**Title:** Permit 24-053: Walser Kia

**Recommendation:**

Approval of MCWD permit application on the following conditions:

Re: MCWD Permit Application #24-053 – Walser Kia  
Revised Exception Request  
File 0036502.00

LANDSCAPE LEGEND

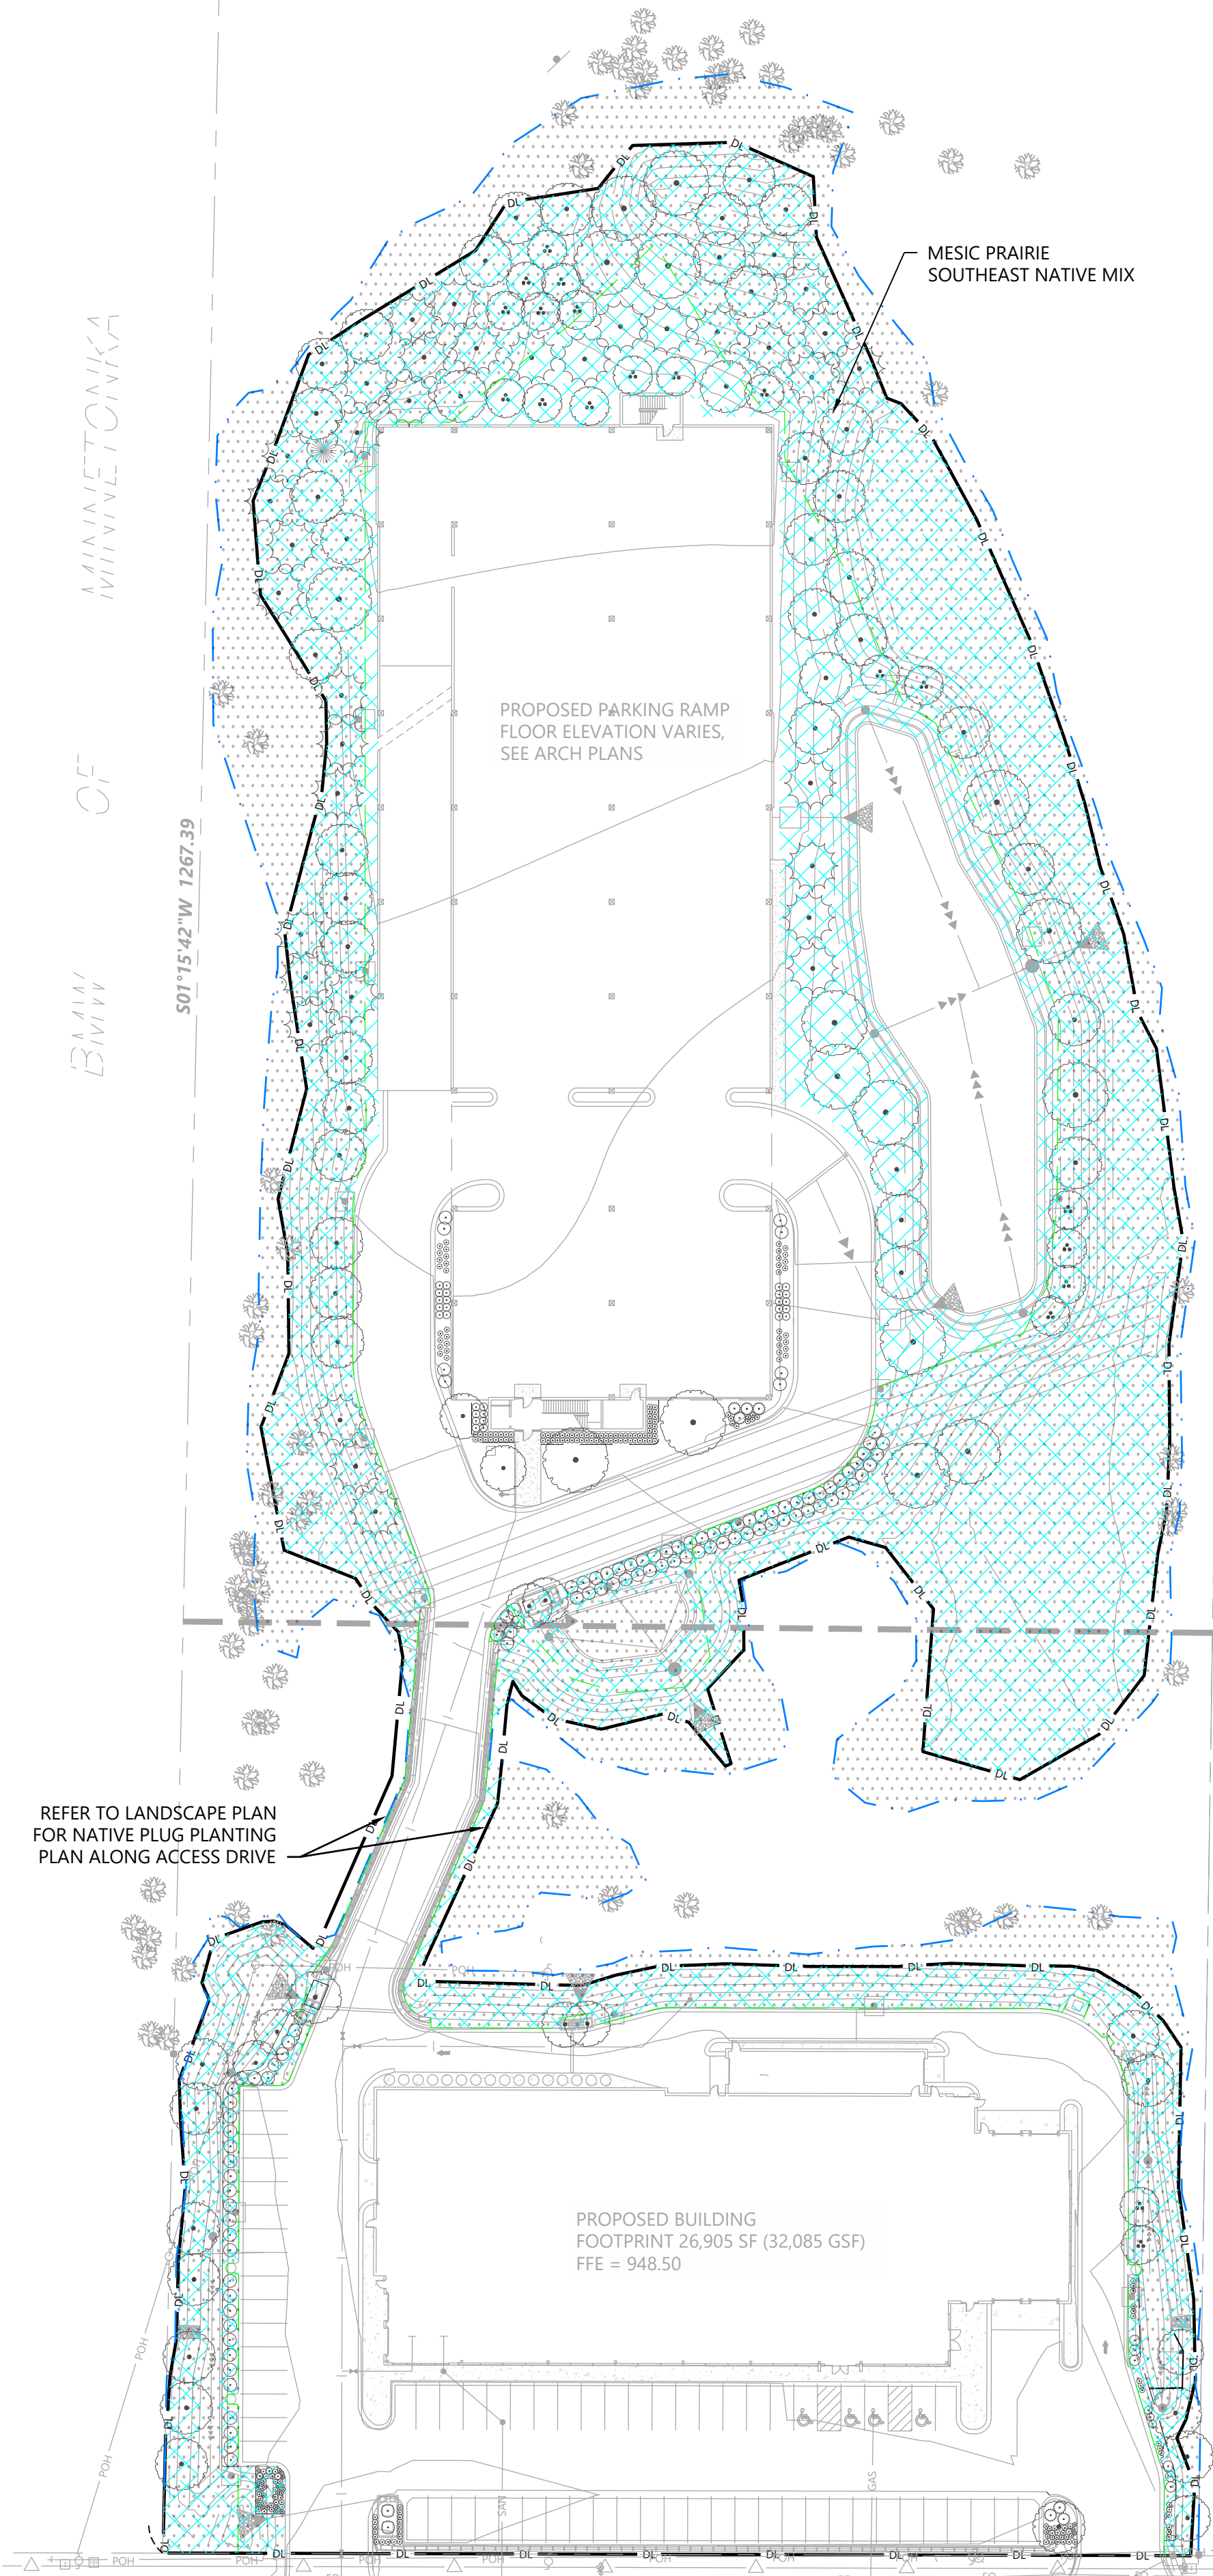
The submitted enhanced wetland buffer planting plan utilizes a Mesic Prairie seed mix (MNDOT Mix 35-641) which will be protected by hydro-mulching or erosion control blanket. In terms of an enhanced planting plan, the Applicant is proposing to go beyond the minimum requirement to re-seed and stabilize the wetland buffer, by installing native trees and shrubs throughout the buffer. These shrubs and trees bring vertical structure, songbird nesting, terrestrial habitat, and pollinator habitat.

On this basis, staff finds that the proposed planting plan will increase the volume and diversity of plant composition within the wetland buffer, beyond that which would be achieved through a standard seeding plan required under the rule.

**PROPOSED  
SITE PLAN**

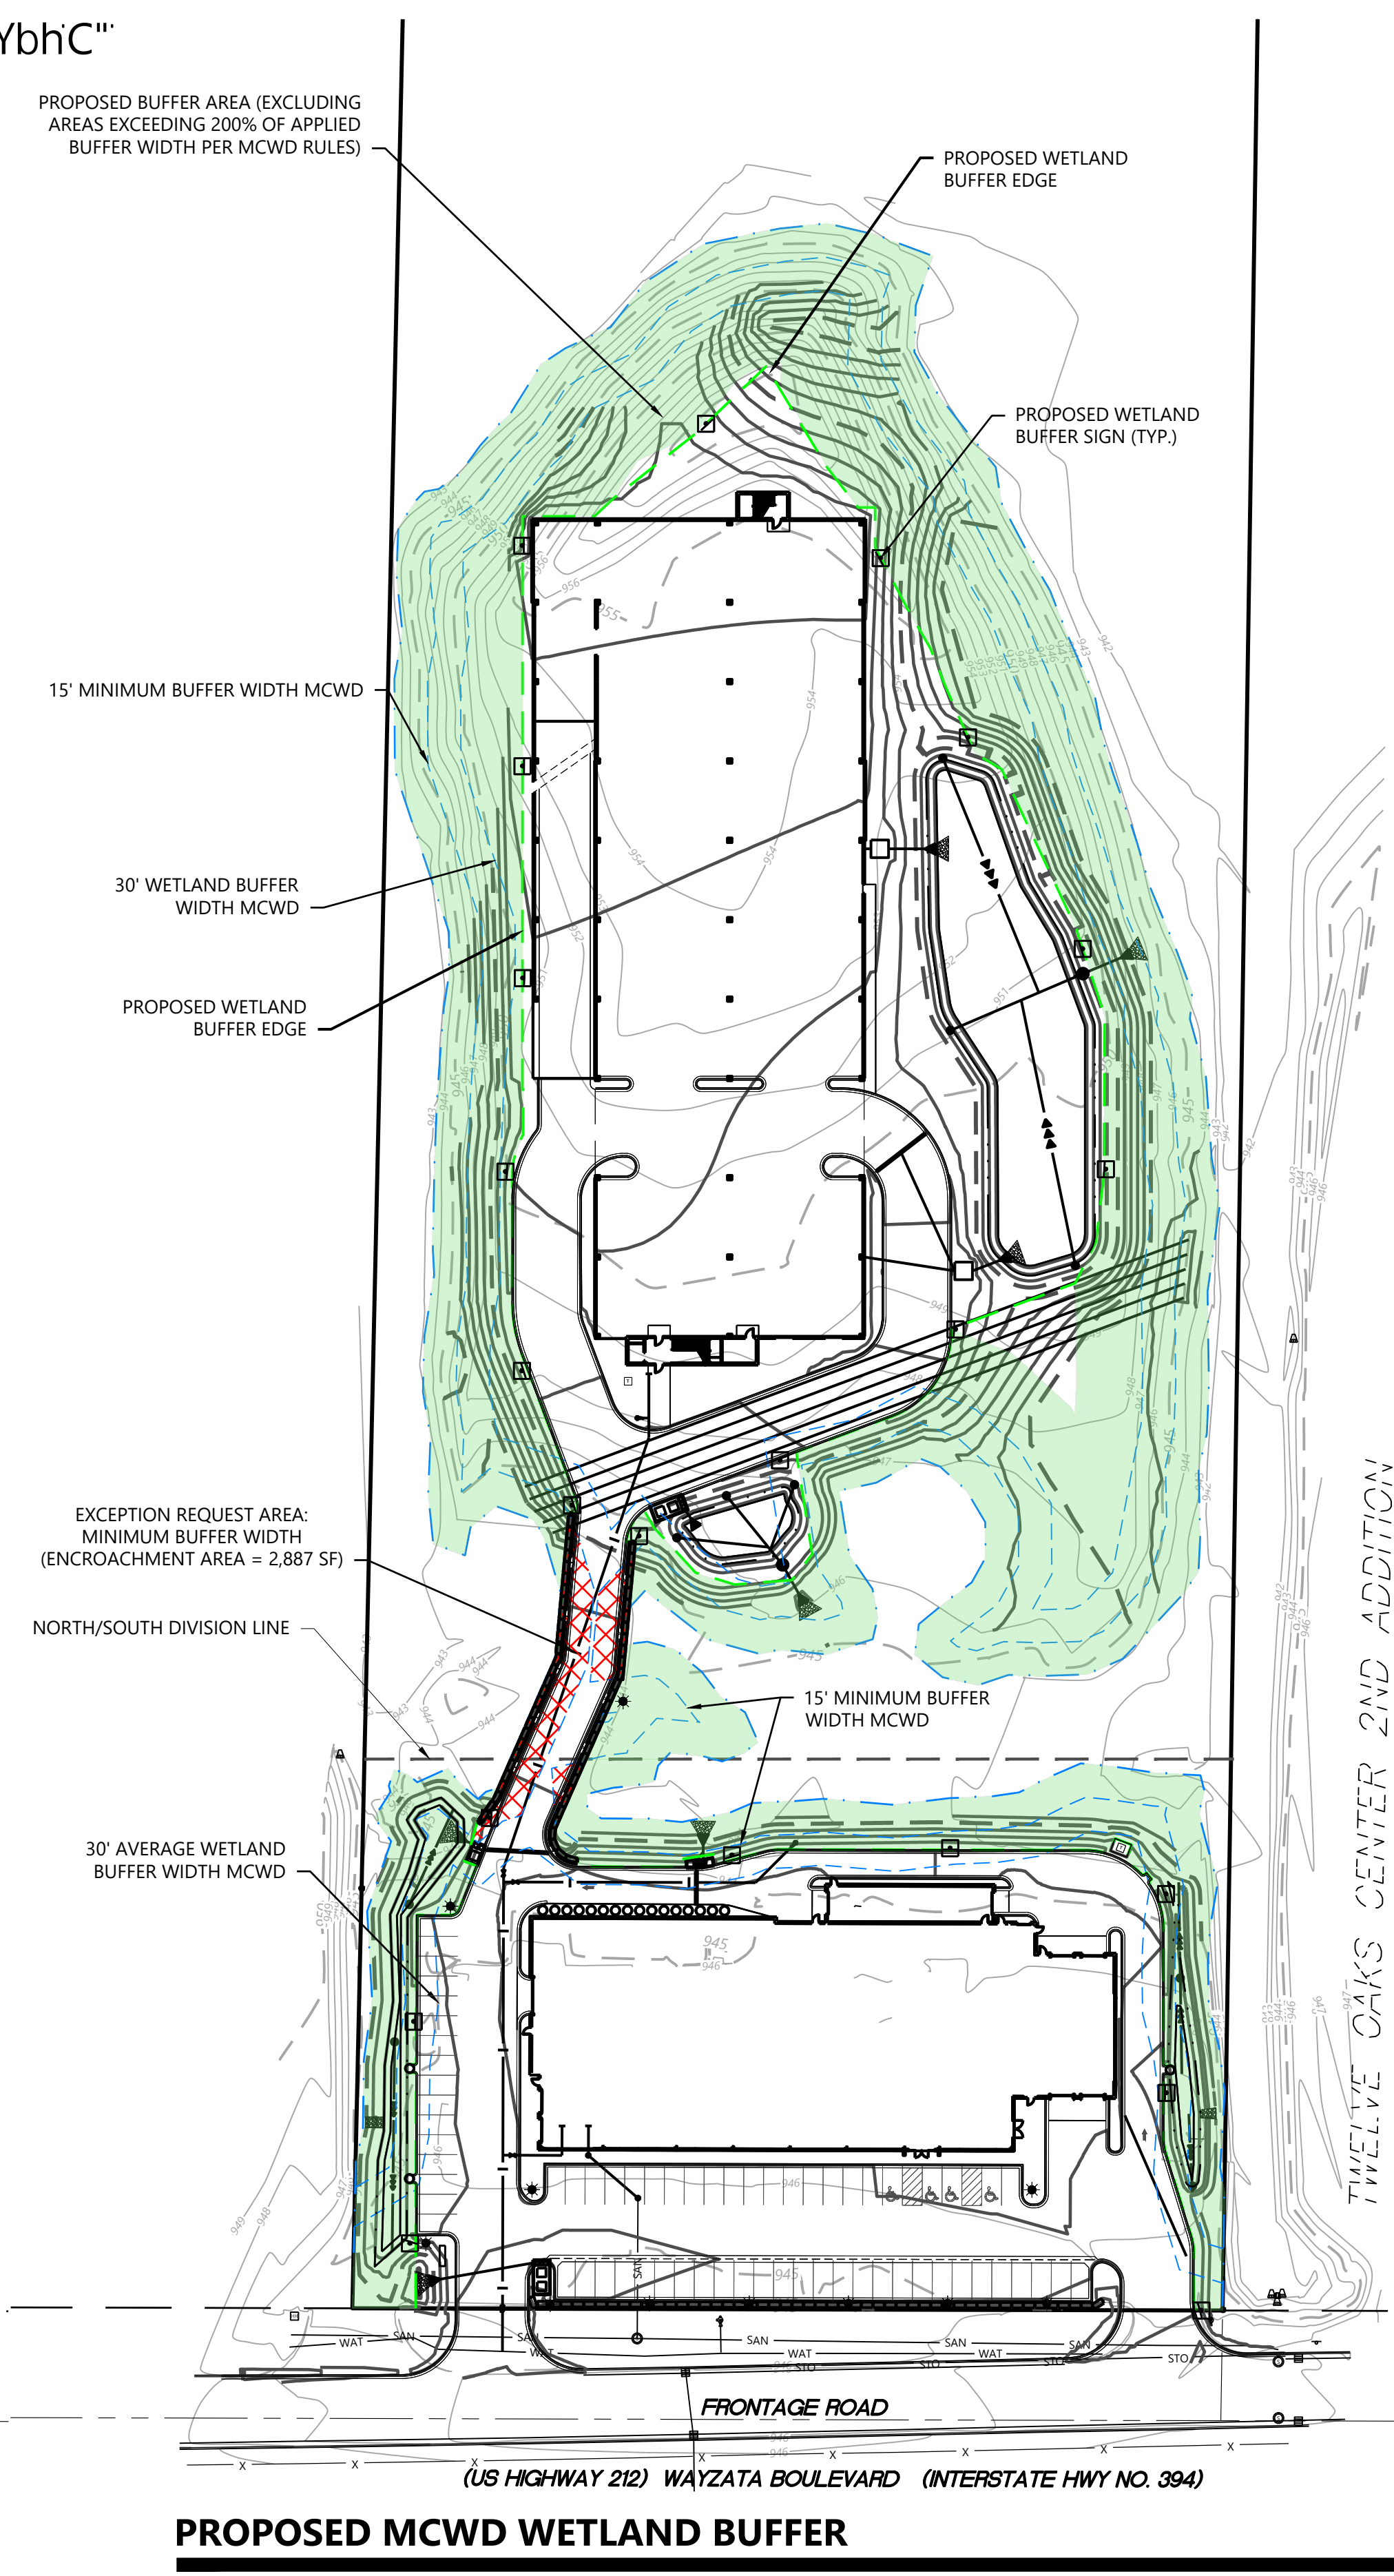
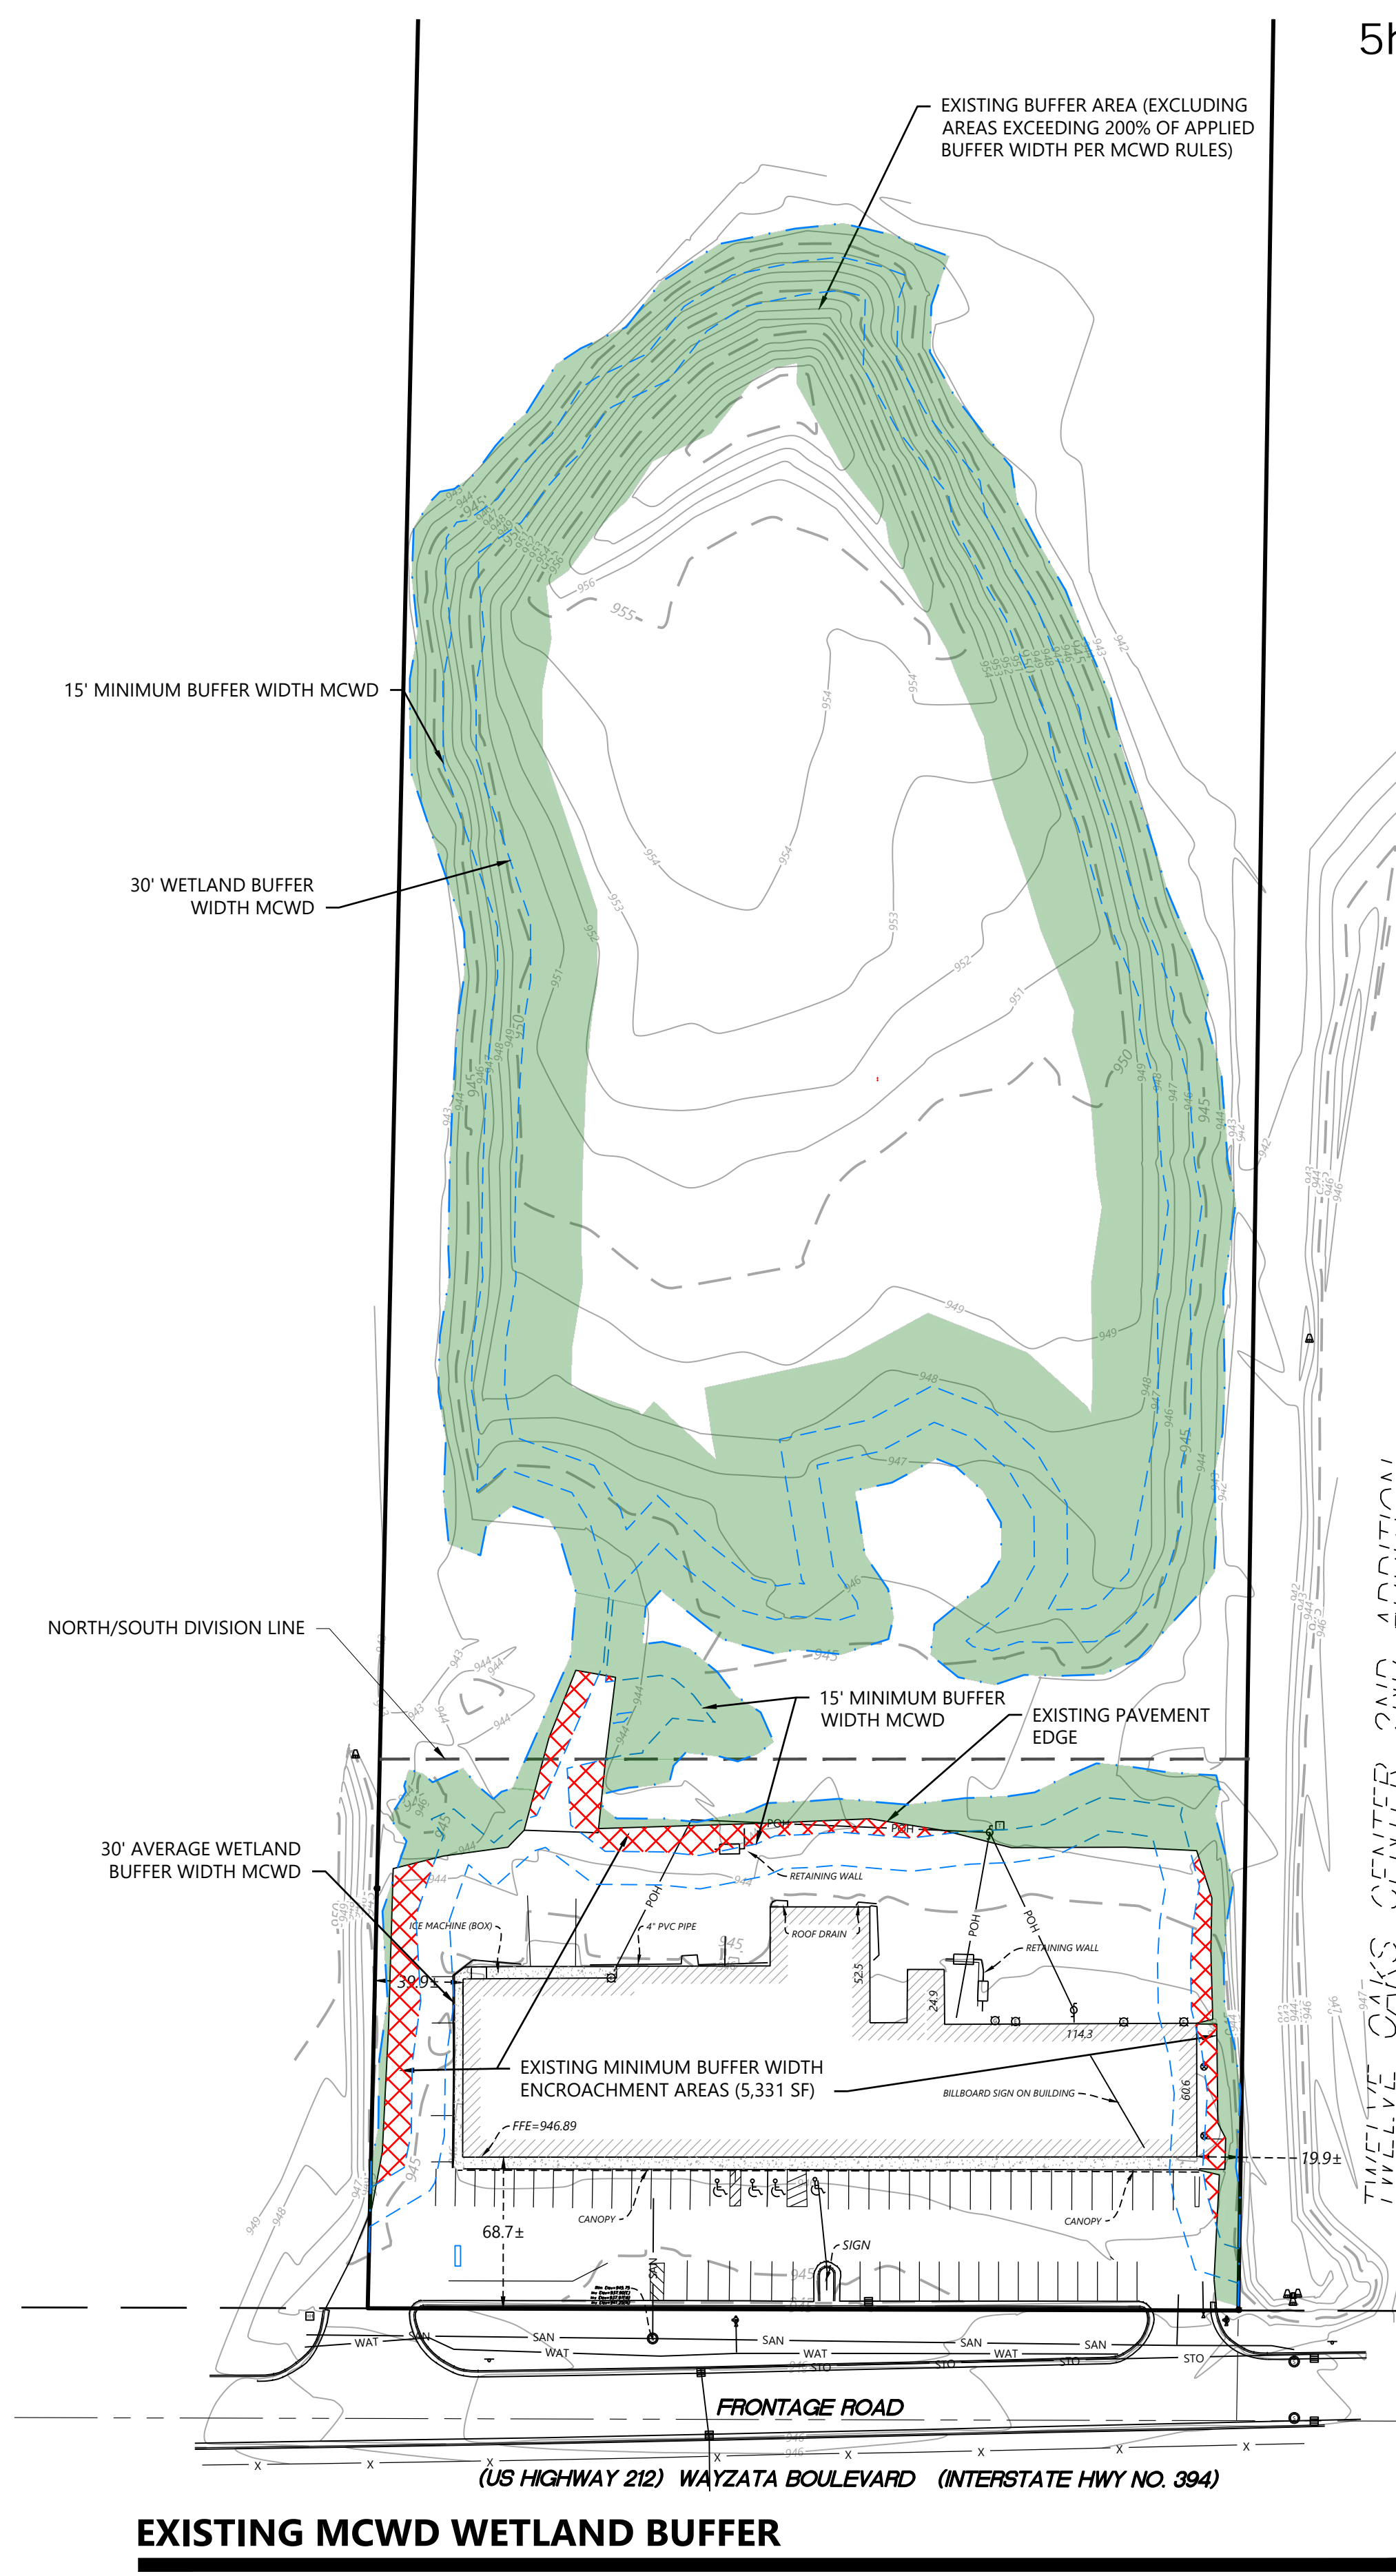
The Applicant's plans indicate 1 location where the minimum buffer width is not provided due to the location of a proposed access road.

Shown on Site Plan Attachment C, there is one segment within the project that does not meet the minimum buffer width. To gain access to the northern portion of the site, a 249 foot long, 22 foot wide drive is required. The placement of the access road was done to avoid permanent wetland impacts and minimize temporary impacts.

For the site as a whole, the required 30-foot average buffer results in 1.99 acres of buffer in total; the Applicant proposes to provide 2.38 acres of buffer, and therefore meets the buffer area requirements. The minimum width is met in all areas except the area on both sides of the access road that do not meet the 15-foot minimum buffer requirement. Along this length, the shortfall in buffer area is 2,887 square feet, with multiple locations proposing a 0.5 buffer width. Details of the shortage are outlined in the Buffer Width Shortfall section below. The Applicant is requesting a minimum buffer width exception for this location.
